ATR on Quality Control Check Report. (Apartments)

Flat No	H-301	QC report stage	Stage-III	Sl. No.	42786
Company	MRMLP	Project	Group	Phase	-
Prepared by	Sahiba	Sign	<i>[Signature]</i>	Date	19/2/24
Project Manager	Navender	Sign	<i>[Signature]</i>	Date	19/2/24
Receipt by QC date		Sign		Other	
Receipt at HO date		Sign		Other	
Checked By MD on		MD Sign		For filling	☐ Yes ☐ No
Recommendation that was made by QC: ☐ Stop further work. Submit ATR on QC report to QC team. Proceed only after recheck by QC. ☒ Stop further work. Proceed with work after submitting ATR on QC report to QC team

GULMOHAR RESIDENCY

Details of Additions & Alterations

Description	Owners & Developers :	Date :	Promoted by
	Direction	16.09.20	Modi Properties Pvt Ltd
		Prepared By :	Jayapradha
		Approved By :	Soham Modi
		Scale :	N.T.S
PLUMBING PLAN-1360 Sft (A2-TYPE)			
Gulmohar Residency			
Phone: +91-40-66335551

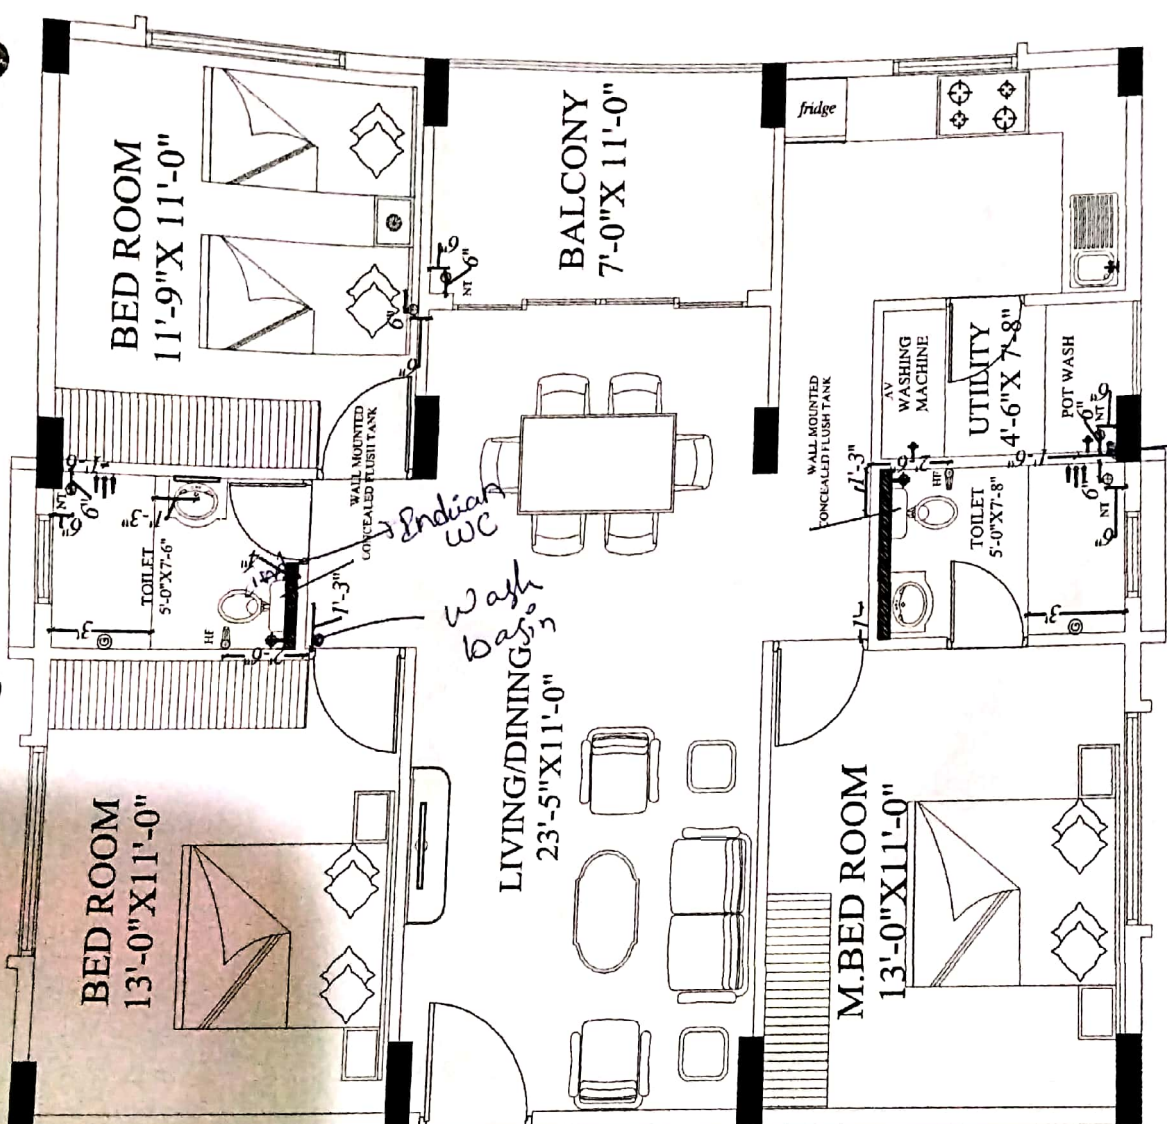
- 1) Kitchen Platform - required as per standard.
- 2) Required electrical switch board in utility.
- 3) Required tiles in open area @ Kitchen & Hall
- 4) Required utility platform @ Extra cost,

ELECTRICAL PLAN -1360 sq ft FLATS-A2 TYPE	Description	Owners & Developers :	Date :	Promoted by
		Modi Reality Mallapur LLP	21.09.2020	Jayapratha
		Project Name & Phase :	Approved By :	Modi Properties Pvt Ltd
		Gulmohar Residency	Scale :	Phone:-91-40-66335551

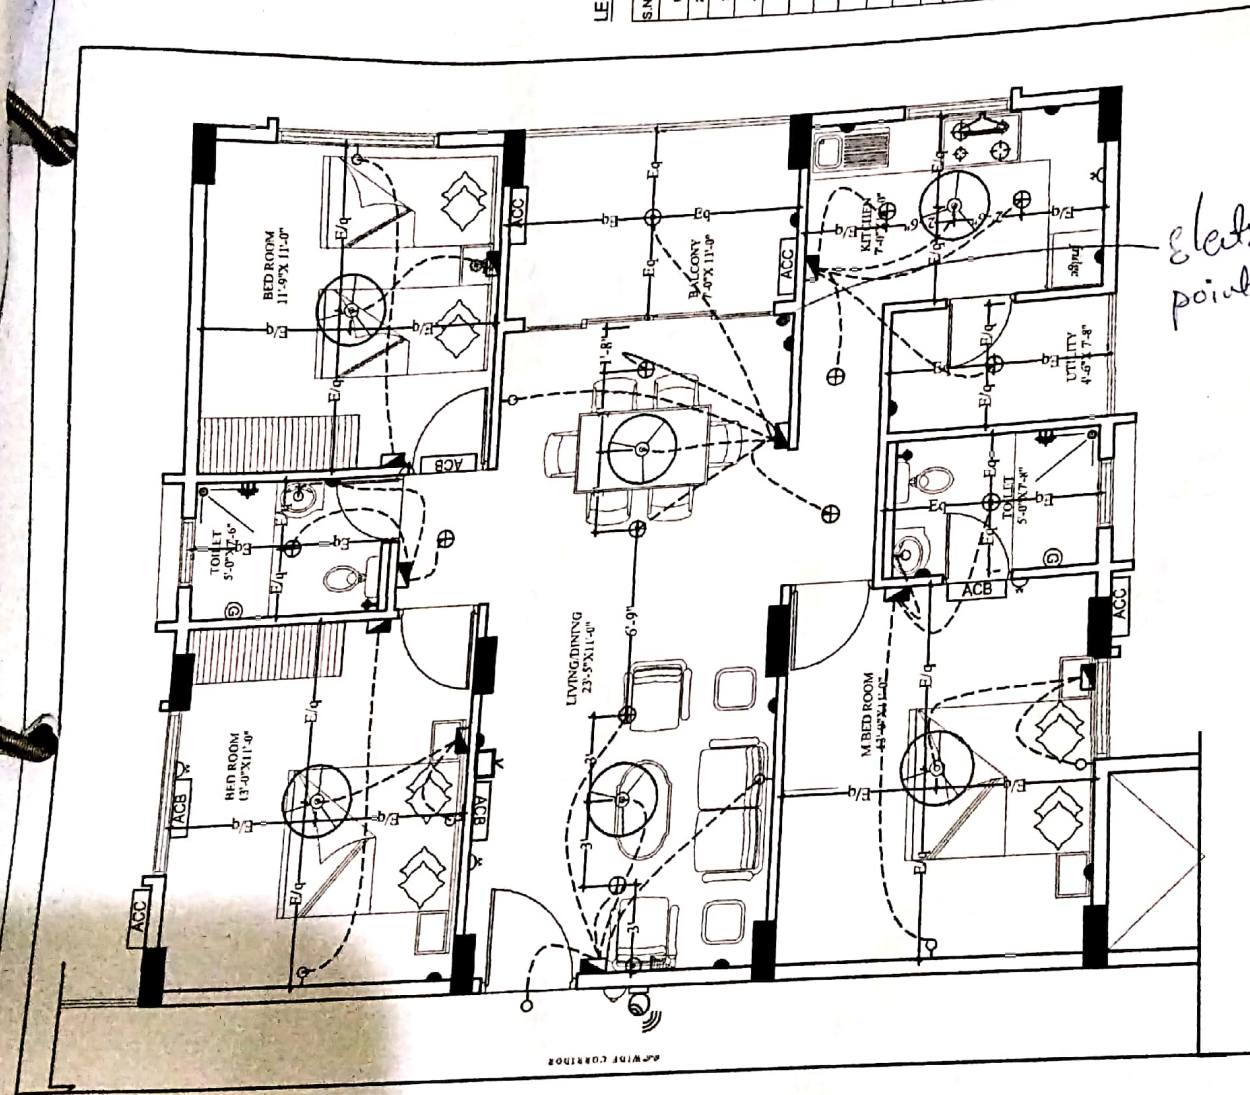
electrical point
